Item Name: Bracket Assembly, LH (Aluminum Doors)

DART SERVICE INSTRUCTION

TO AMEND INSTALLATION INSTRUCTIONS IIN-D412-698 REV. E OR LATER APPROVED REVISION
AND ICA-D412-698 REV. 5 OR LATER APPROVED REVISION

FIGURE 1: D3199-3/-4 BRACKET INSTALLATION ON ALUMINUM DOORS
(-4 SHOWN, -3 OPPOSITE)

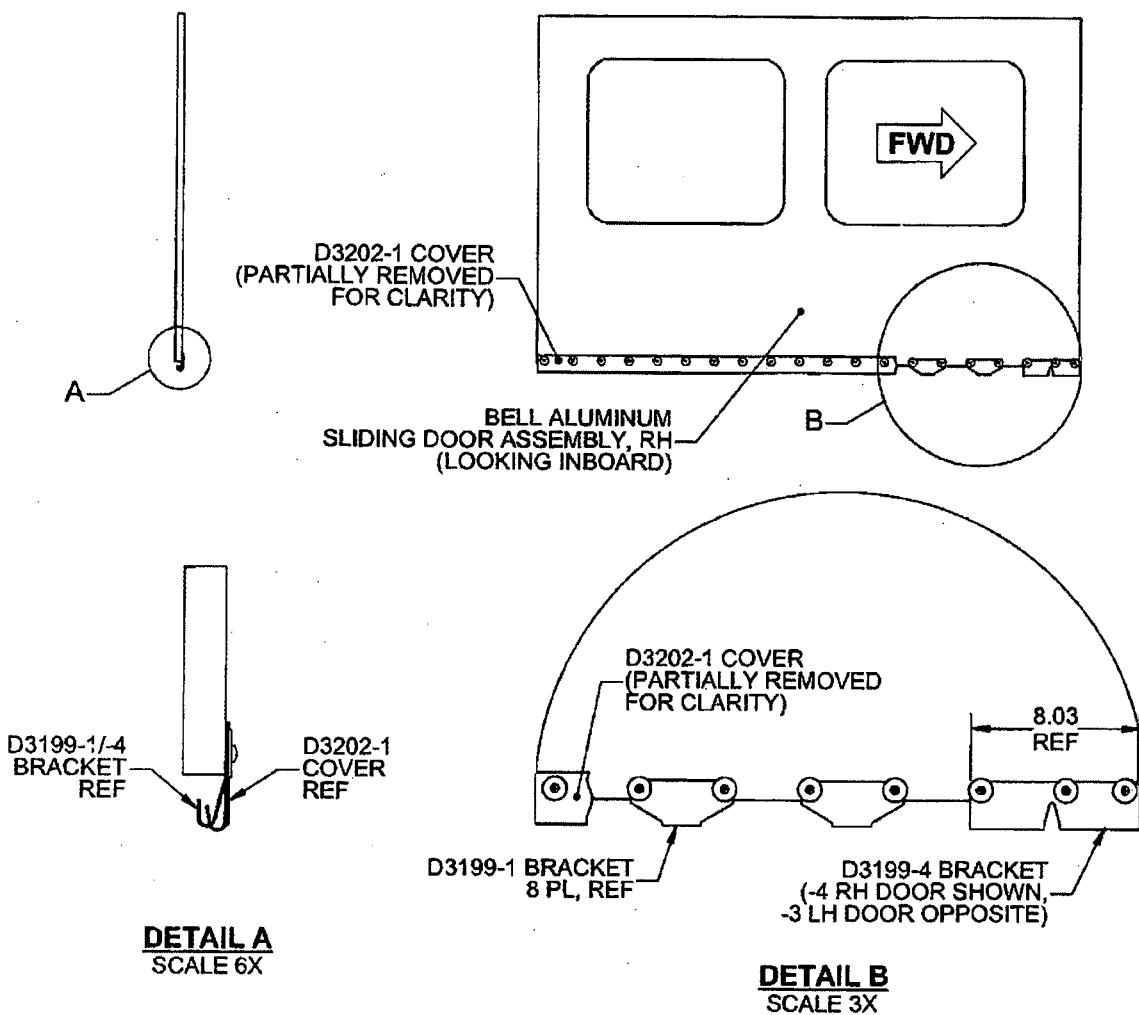
Field experience has shown that the forward D3199-1 brackets that are part of the D412-698-011/-012/-017 Cabin Door Roller Kits and forward D3675-1 brackets that are part of the D412-698-031/-032/-033 Cabin Door Roller Kits may wear prematurely if the aircraft is flown a significant amount of time with the sliding doors open. Dart has developed the D412-698-027/-028 kits that includes a longer D3199-3/-4 bracket for installation in the first forward position of the D412-698-011/-012/-017 kits to reduce wear on these forward brackets on aircraft equipped with aluminum doors. Likewise, Dart has developed the D412-698-037/-038 kits that includes a longer D3675-5/-6 bracket for installation in the first forward position of the D412-698-031/-032/-033 kits to reduce wear on these forward brackets on aircraft equipped with composite doors.

- 1) Remove the sliding door from the aircraft per Section 52.1 of ICA-D412-698
- 2) Remove the first forward D3199-1 or D3675-1 brackets as applicable.
- 3) Install the D3199-3/-4 or D3675-5/-6 bracket as applicable in lieu of the removed -1 bracket. Refer to Figure 1 Sheet 2 (aluminum doors) or Figure 2 Sheet 3 (composite doors).
- 4) Torque hardware per ICA-D412-698.
- 5) Re-install sliding door on aircraft per Section 52.2/52.3 of ICA-D412-698 as applicable.
- 6) Make entry in technical records of aircraft indicating that DSI 9484 has been completed.
